# Proposed Residential Development – Land West of Thaxted Road, Saffron Walden

## Stage 1 Road Safety Audit / Designers Response

**ROAD SAFETY AUDIT  
STAGE 1**

# Road Safety Audit Response for Stage 1 Road Safety Audit (GG 119 Appendix F)

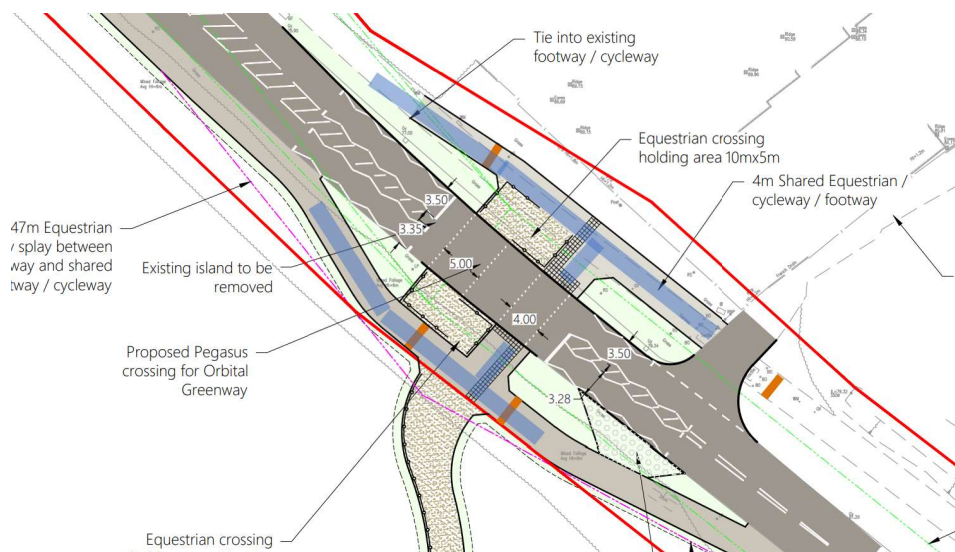
**Location:** F – Shared Use area to the North-West of TipTofts Lane  
**Summary:** Use of Corduroy Paving as shown may confuse visually impaired pedestrians and cyclists as to the facility they have entered.

The drawings provided show several orange bands located within the vicinity of the Pegasus/Toucan Crossing. Due to the location of the orange bands, it has been assumed that these notate an area of corduroy paving. Corduroy paving is usually introduced to detail the change in a facility, for example the end of a shared use facility. As shown below, the areas marked in blue are all shown as shared use facilities.

Within the area that these have been proposed the facility for visually impaired pedestrians (which the corduroy paving is primarily introduced for) the facility has not changed. By providing this band of corduroy paving a visually impaired pedestrian may think that they have now entered an area of footway only and that the risk of strike from cyclists is no longer a concern, making them vulnerable to strike by approaching cyclists.

**RECOMMENDATION:** It is recommended that corduroy paving at these locations are removed.

<p>RSA Recommendation</p>	<p>It is recommended that corduroy paving at these locations are removed.</p>
<p>Design Organisation Response</p>	<p>Agreed - Corduroy paving removed. Back to back signs to Diag. 956 (shared footway/ cycleway) and 956.1 (shared footway/ cycleway/ equestrian) added.</p>
<p>Overseeing Organisation Response</p>	
<p>Agreed RSA Action</p>

Drawing Number: 22078/006

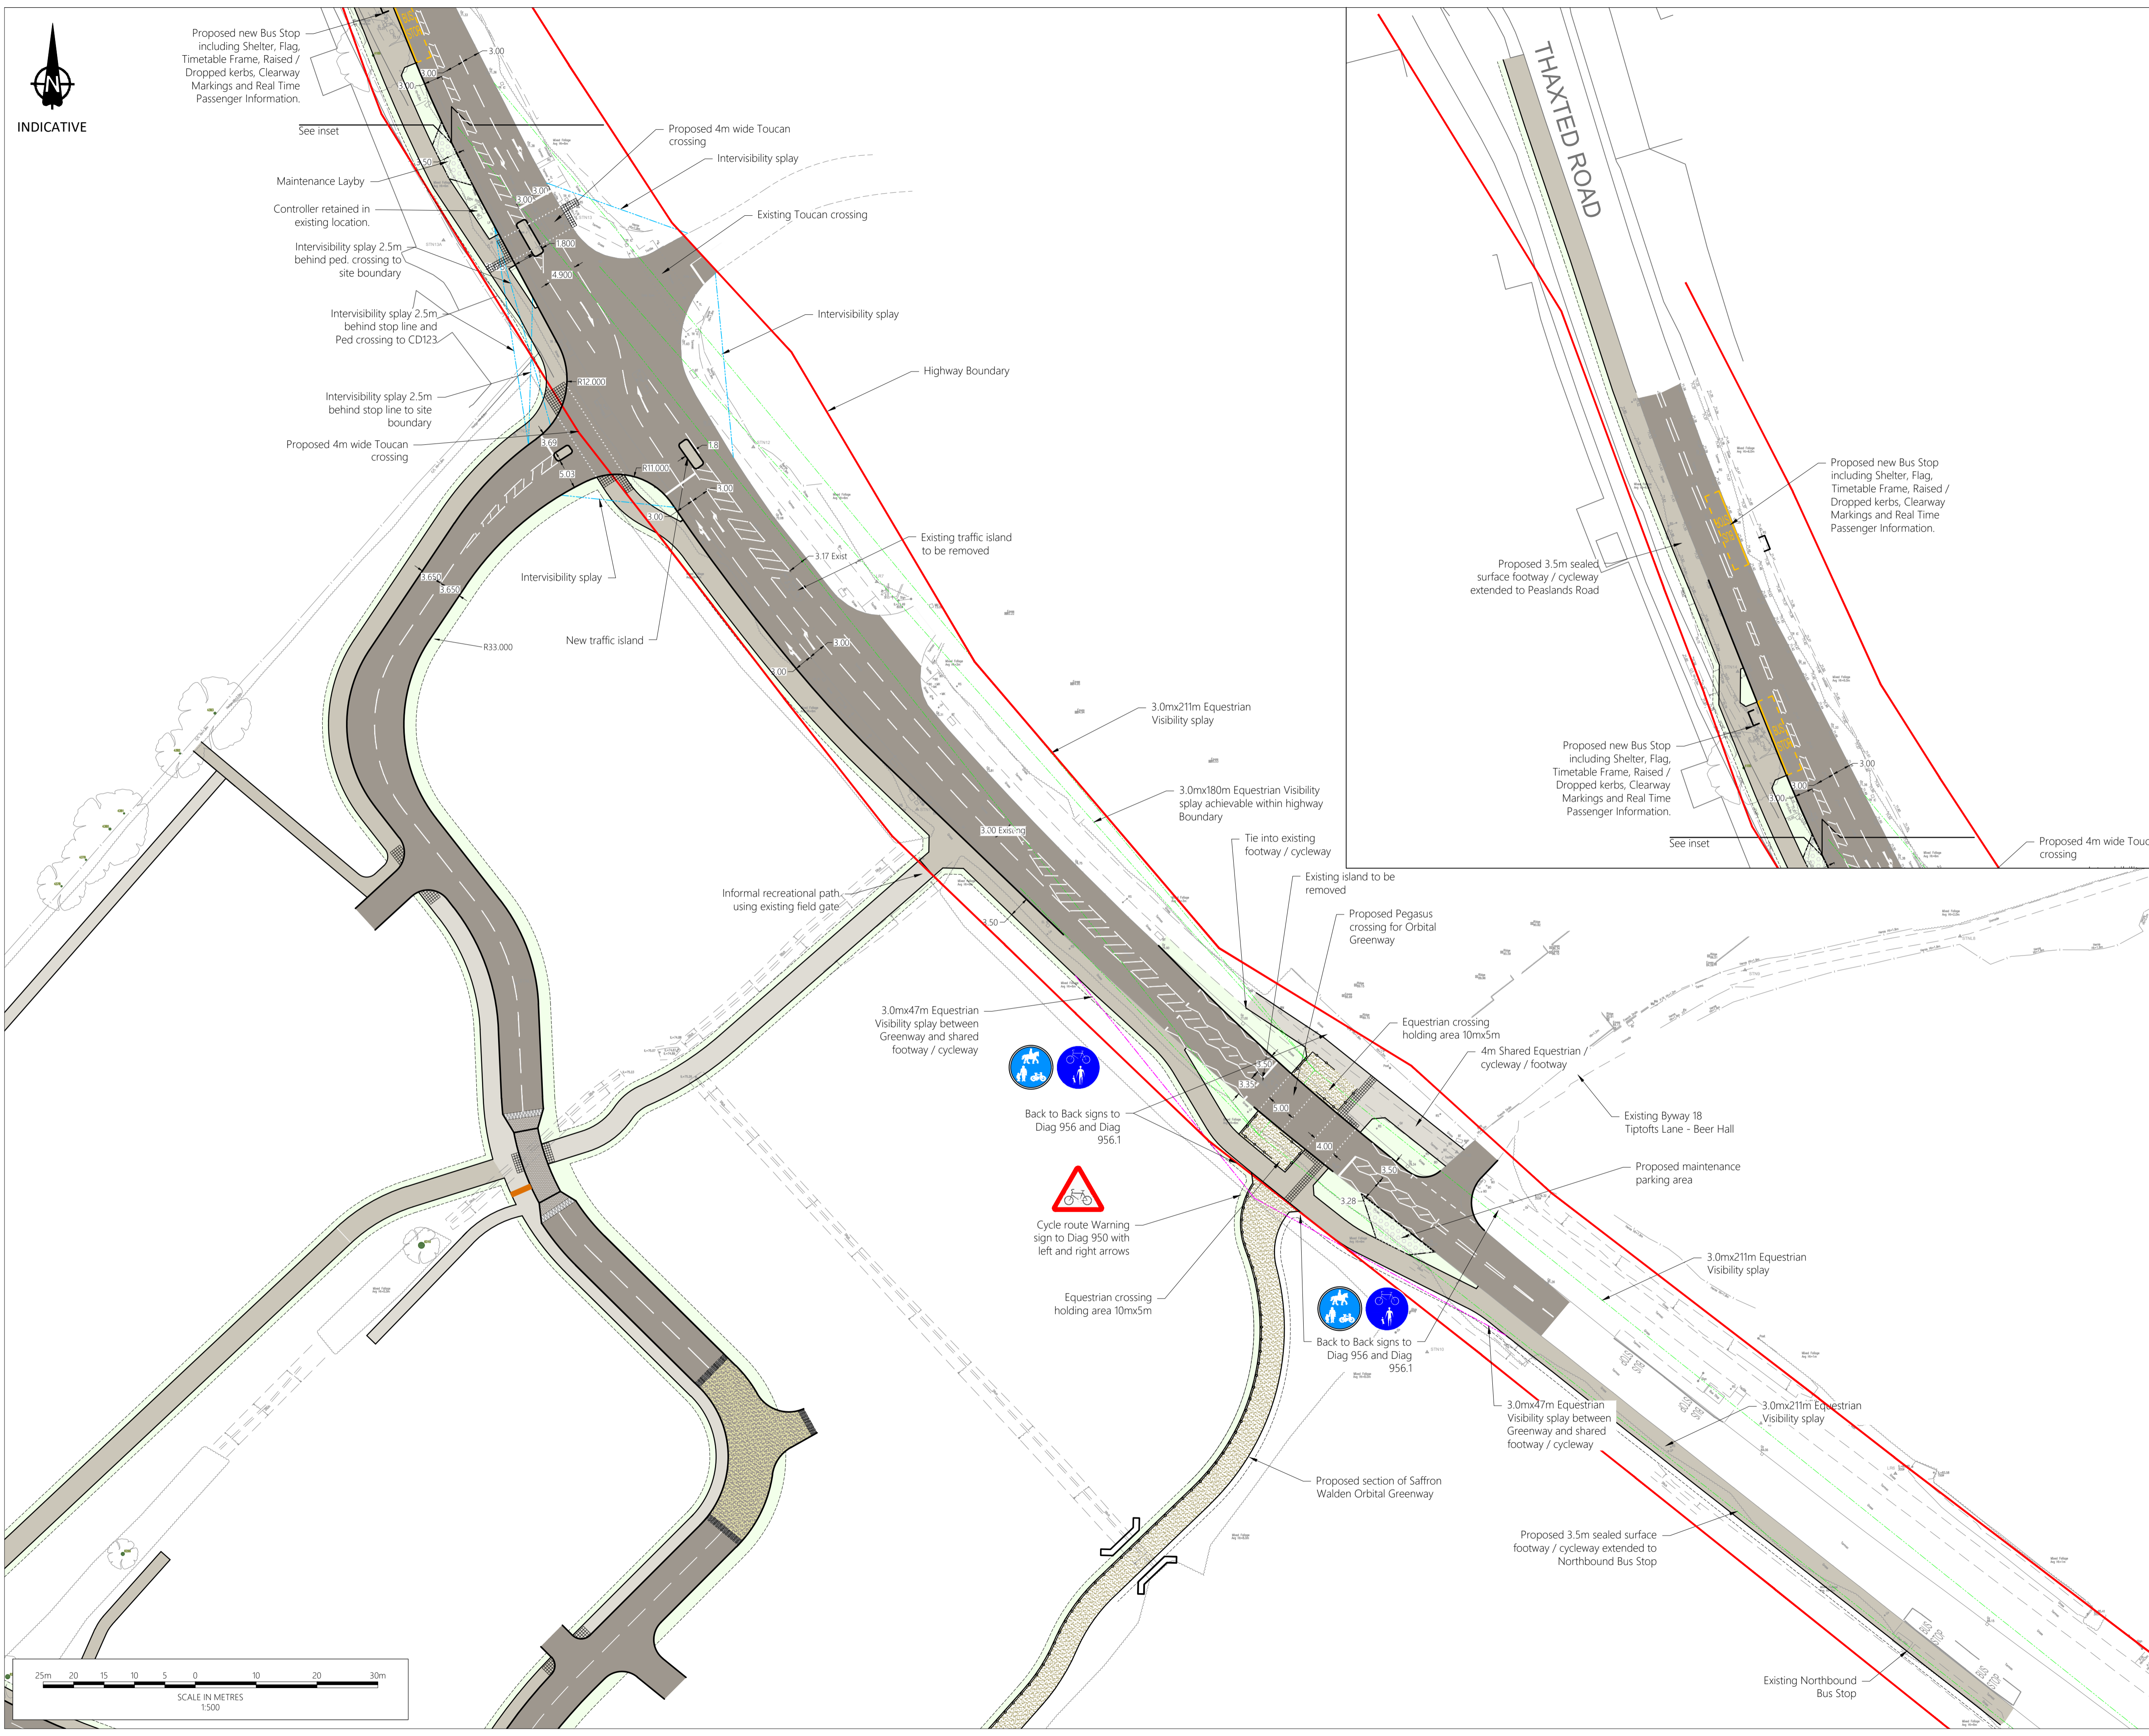
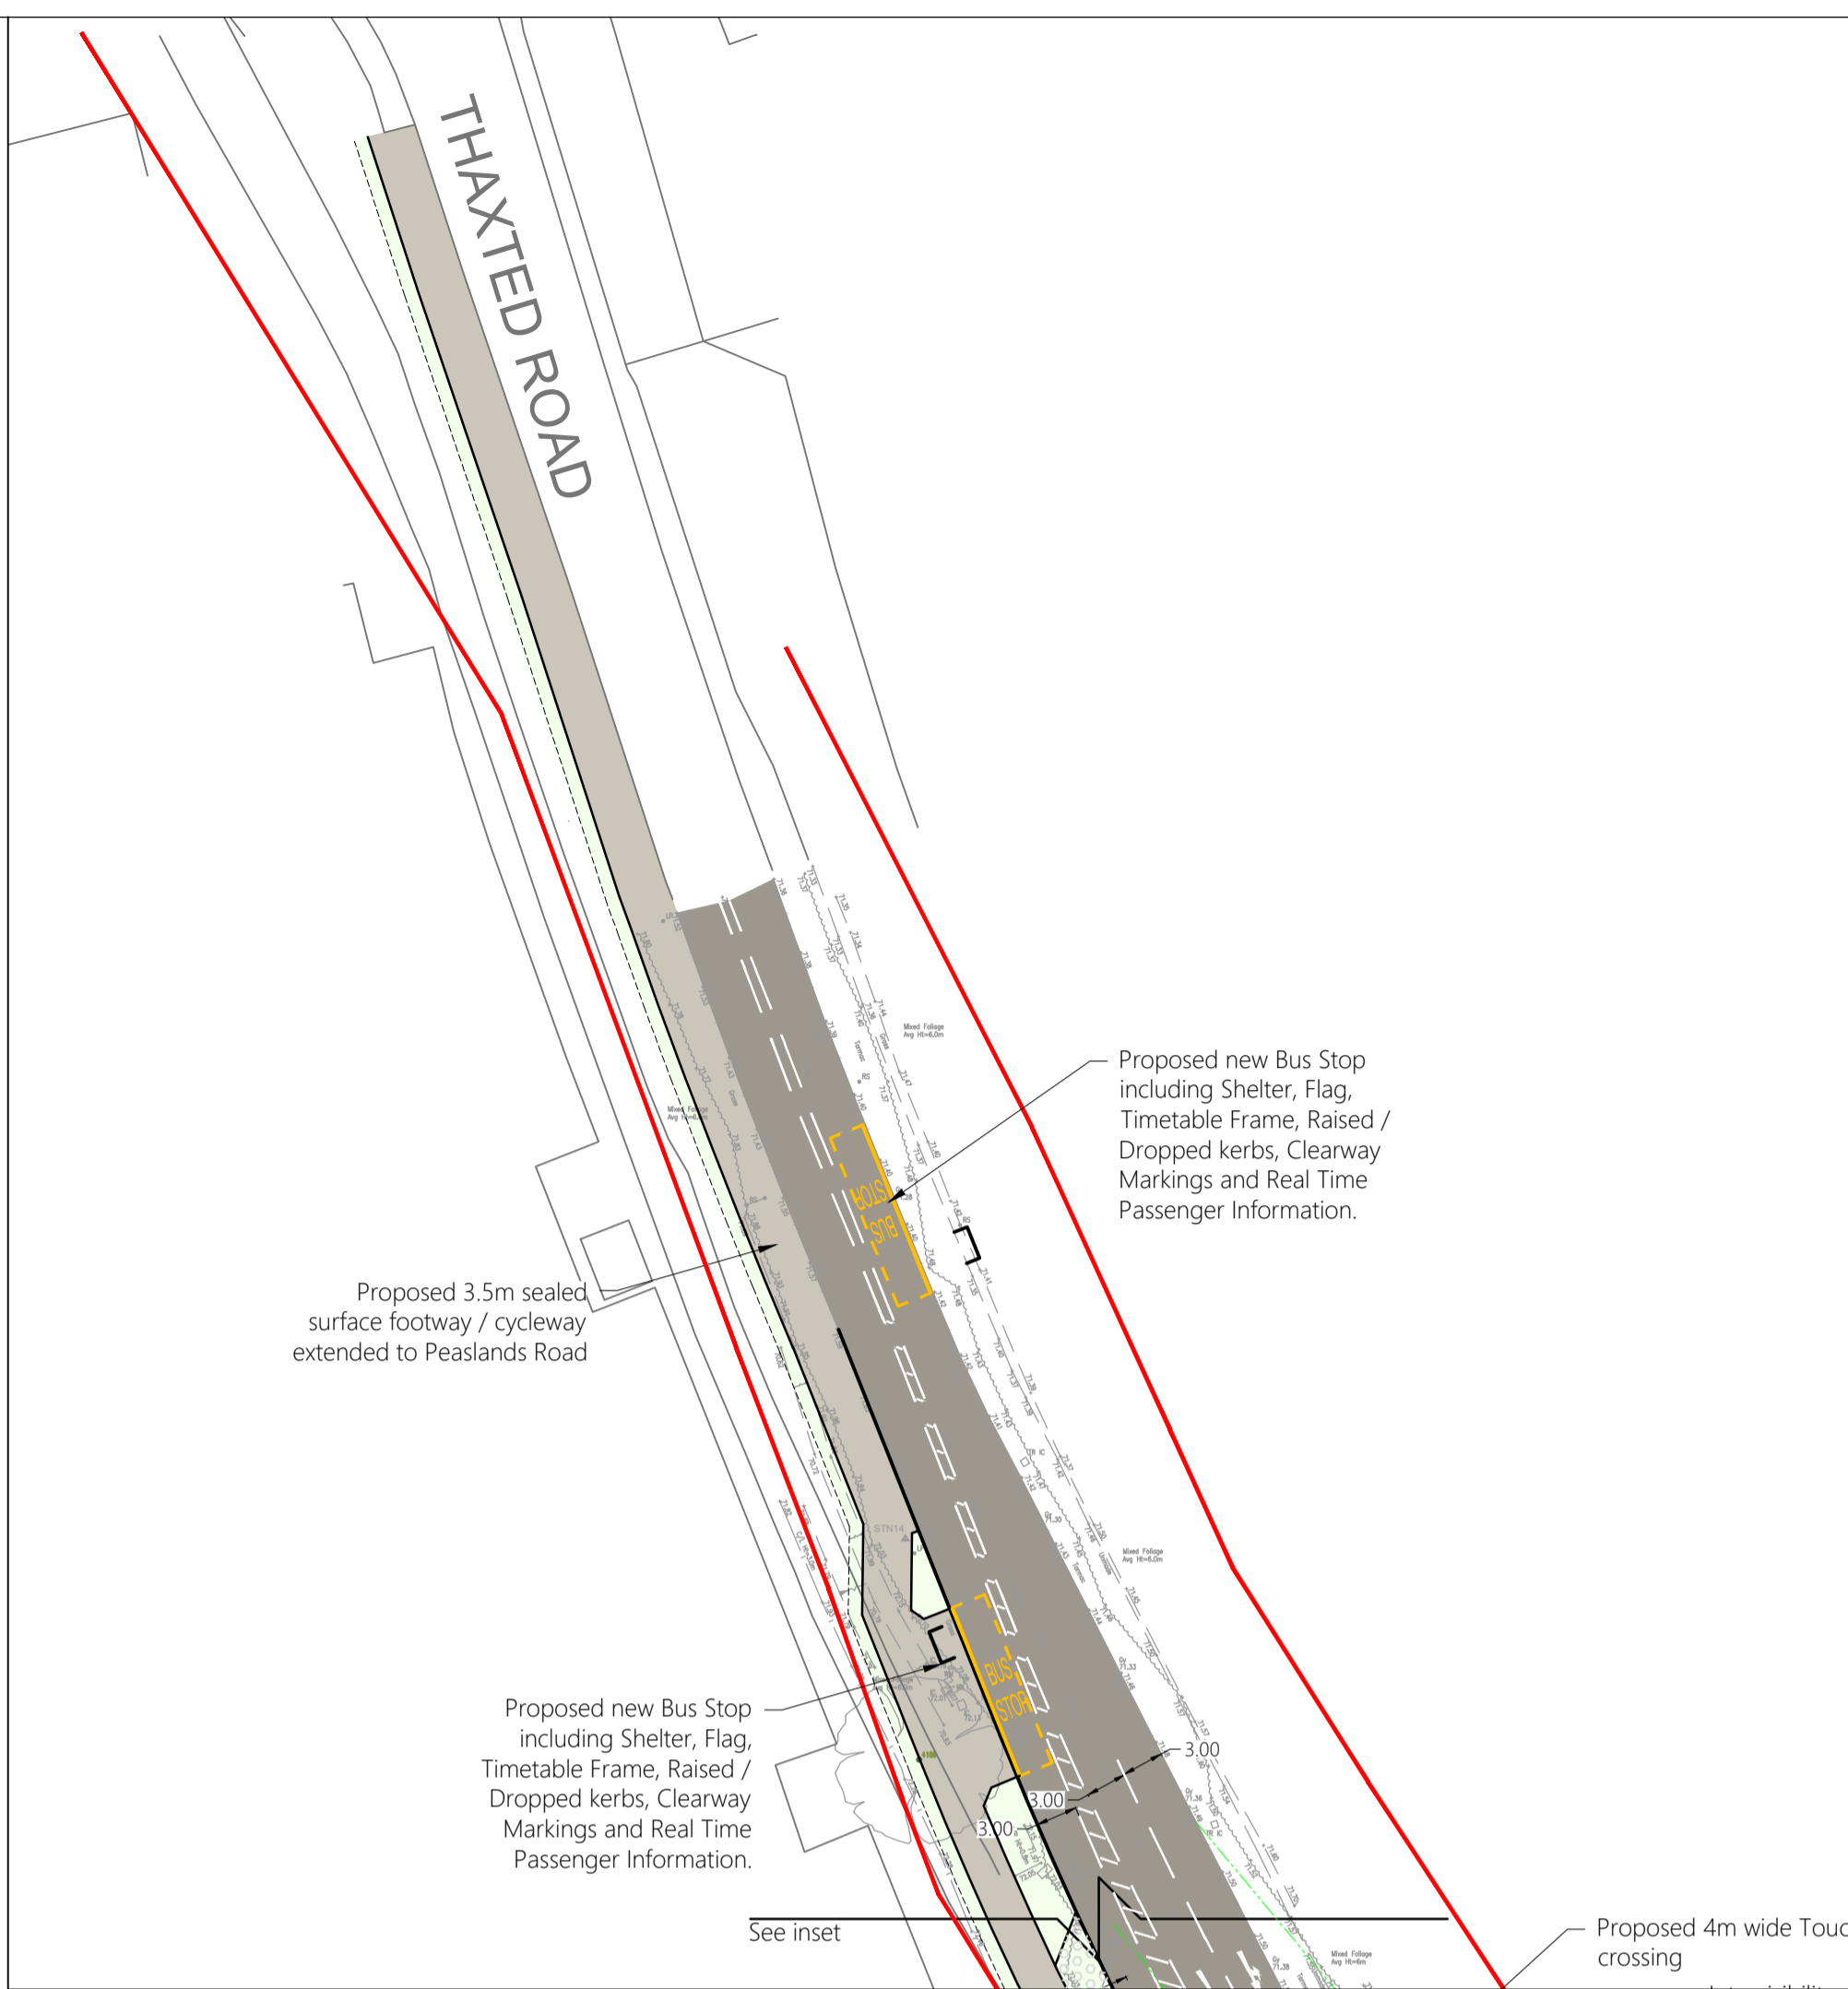
Rev:	Drn:	Date:	Details:	Chk:
-	BM	06/02/2023	First issue	MS
A	BM	08/02/2023	Layout amended.	MS
B	BM	13/02/2023	Layout amended.	MS
C	BM	17/02/2023	Shading added	MS
D	BM	24/02/2023	Amended following Stage 1 RSA	MS

<p>Design Organisation Response</p>	<p>Agreed – Incorrect tactile paving amended and tactile paving added to signalised junction. All Tactile paving will be in accordance with the 'Guidance for the Use of Tactile Paving' standards</p>
<p>Overseeing Organisation Response</p>	
<p>Agreed RSA Action</p>

<p>RSA Problem</p>	<p>Summary - Right turn arrows direct drivers into the opposing lane/footway. This may result in confusion and hesitation between drivers resulting in sudden braking and subsequent rear end shunts or obstruction of the junction.</p> <p>Detail- The centre of the staggered signalized junction between Cardamon Road and the new junction has two right turn arrows proposed. These arrows appear to direct drivers into the footway and the opposing lane of Cardamon Road. Placing the arrows as such may cause driver confusion as they locate themselves at obscure locations to turn right into the relevant junction. Confusion leads to hesitation, which may lead to rear end shunts or obstruction of the junction.</p>
<p>RSA Recommendation</p>	<p>It is recommended that the carriageway markings are reconfigured within the junction.</p>
<p>Design Organisation Response</p>	<p>Agreed – Carriageway marking reconfigured, arrows to Diag 1038 replaced with Diag 1038.1 Curved markings added.</p>
